COMMUNITY DEVELOPMENT DEPARTMENT REPORT

HEARING DATE: 4/17/2025

SUBJECT: H-2024-0067
Mondt Meadows Subdivision AZ,
CPAM, PP

LOCATION: 6101 and 6162 S. Tarrega Lane, located
in the SE ¼ of the SW ¼ of Section 31,
T.3N, R.1E, Parcels S1131346650 and
S1131346605

D. Preliminary Plat (date: 4/7/2025)

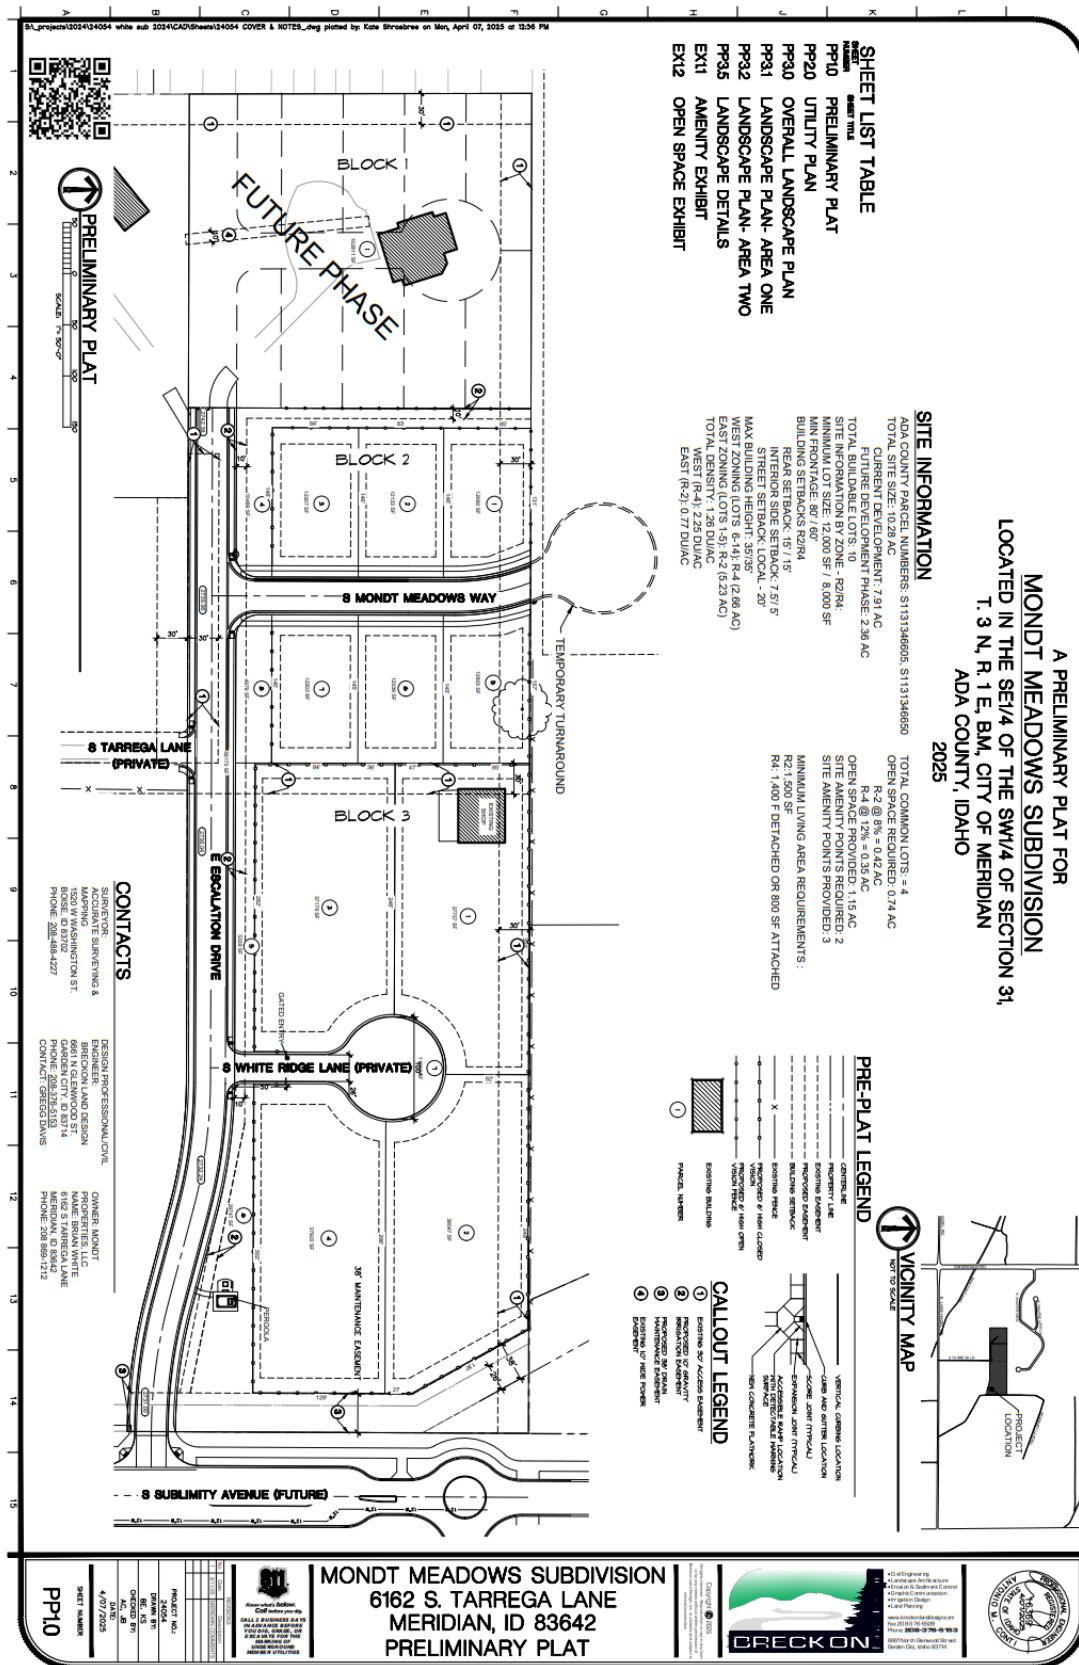
- 2. Submit the following revisions for the Preliminary Plat included in Section VII, dated 3/17/25:
 - a. Revise the plat map to depict the dry ditch on parcel # S1131346650 and its associated easement or provide written documentation showing the dry ditch had been abandoned and is no longer in use by the affected property owners.

- b. Lots shall meet the dimensional requirements of the R-2 and R-4 zoning districts per UDC 11-2A-4 and UDC 11-2A-5.
- 3. The Landscape Plan included in Section VII, dated 3/17/25, shall be submitted for review and approval with the following revisions prior to final plat approval:

E. Landscape Plan (date: 4/7/2025)

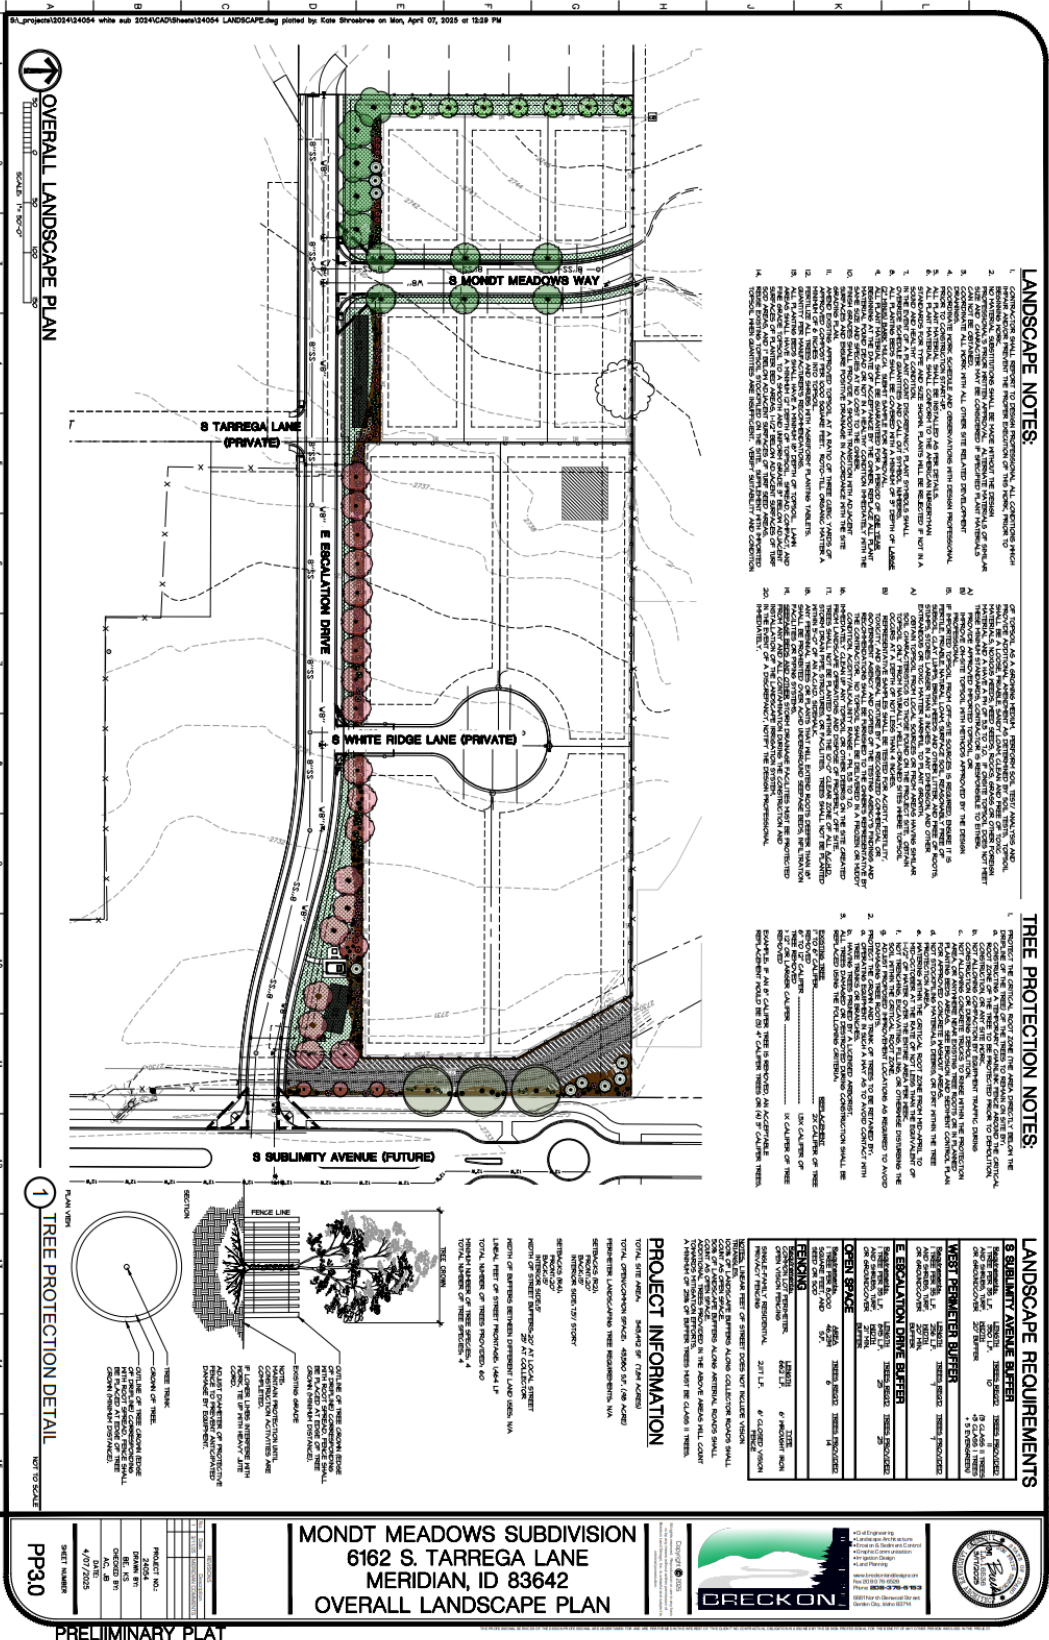
- a. Show the open vision fence location.
 - b. Tree mitigation for the future development shall be addressed on the revised landscape plan submitted with the final plat application.
